Docket No. 52-021  
MHI Ref: UAP-HF-09009

**Subject: MHI's Second Responses to US-APWR DCD RAI No. 88-1438**

Second Responses to Request for Additional Information  
No.88-1438 Revision 1

**US-APWR Design Certification**

Figure 19-149-1 Schematic diagram of refueling outage

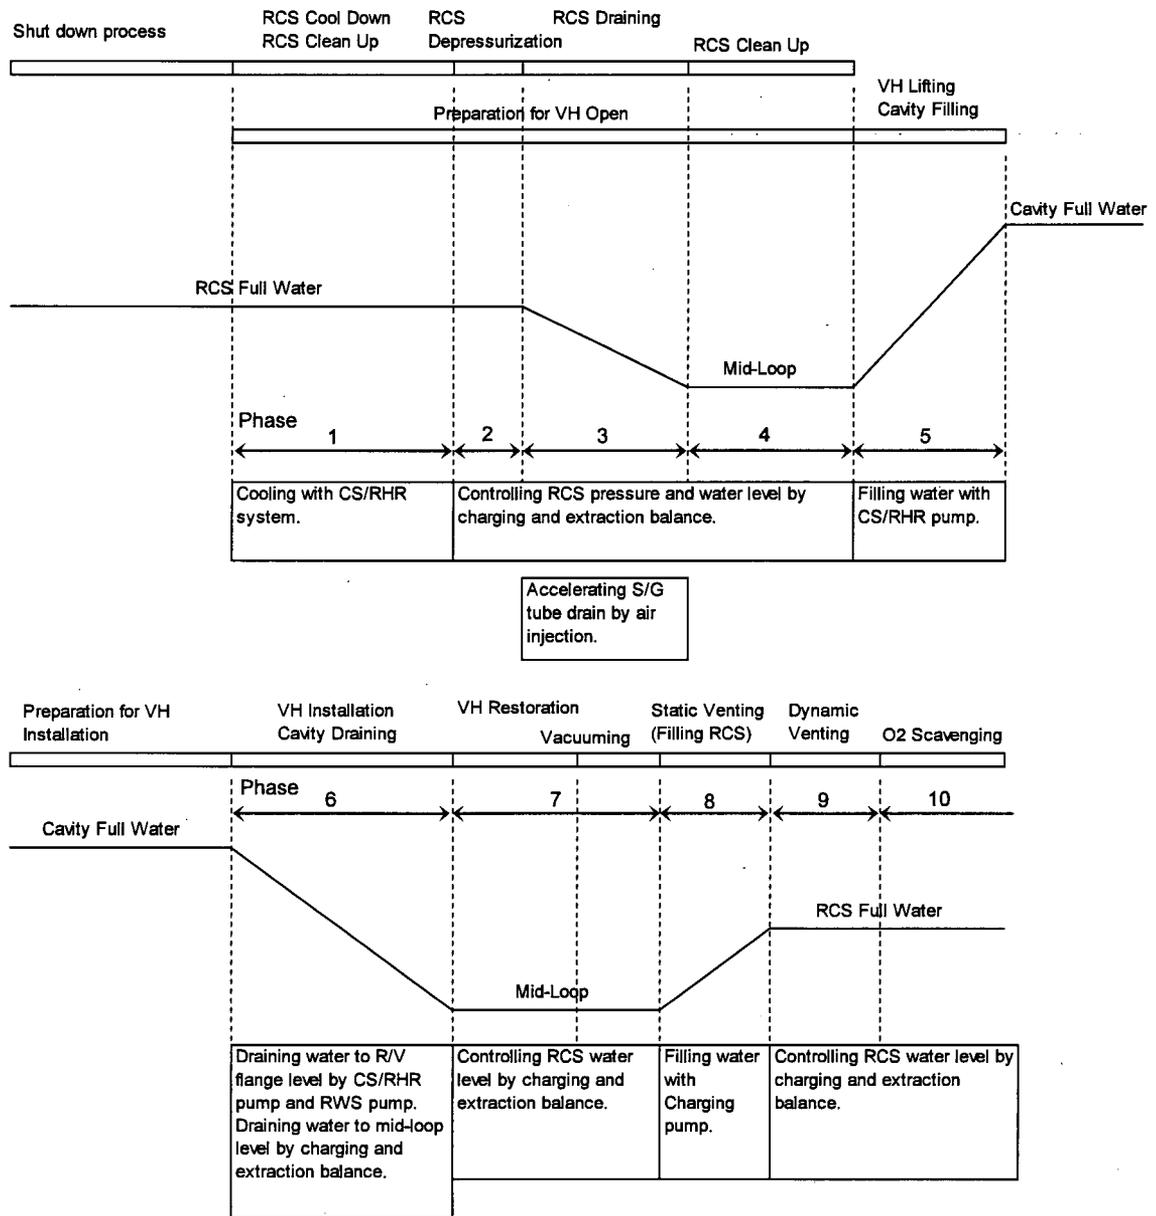
(Follow-up to Question 19-76) The figures provided in response to Question 19-76 do not include enough detail for the staff to understand the US-APWR shutdown strategy. Supplement the figures with a text description, including systems and equipment in use (e.g., for depressurization, air injection to steam generator tubes, and vacuuming), necessary operator actions, and indication of when MODE and POS changes occur.

The outline of the US-APWR shutdown sequences are described as followings. Schematic diagrams of refueling outage are shown in Figure 19-149-1.
